PRODUCT BULLETIN

3" Monitor Flange Connection Change

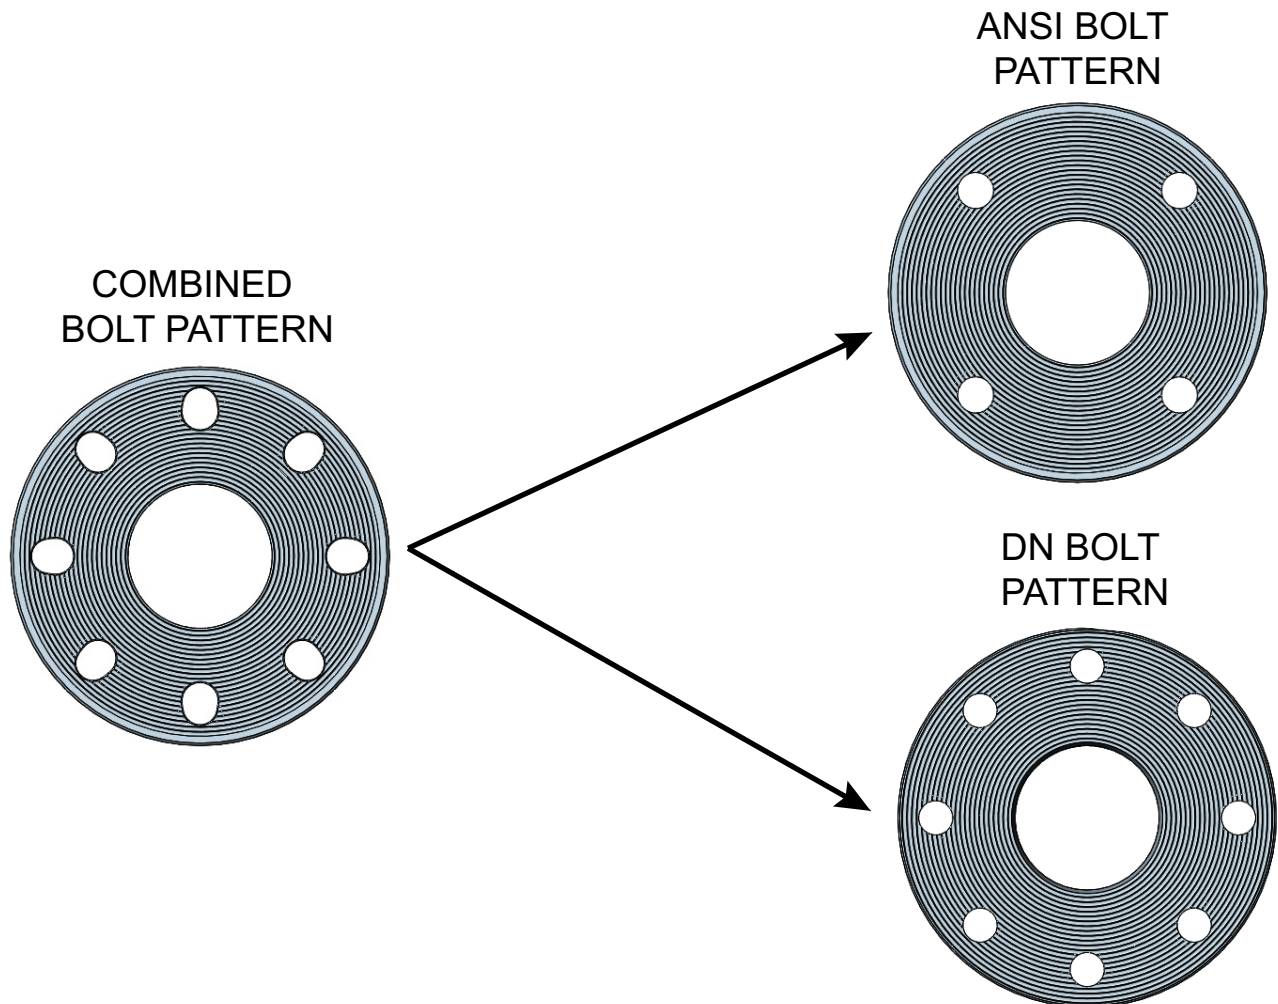
In response to customer feedback regarding the recent change combining the 3" flanges into a single flange with ANSI and DN bolt hole patterns, a design change has been made to separate 3" monitor connection flanges to the original single-pattern configurations.

CURRENT DESIGN
Through 10/31/2022

UPDATED DESIGN
Beginning 11/1/2022
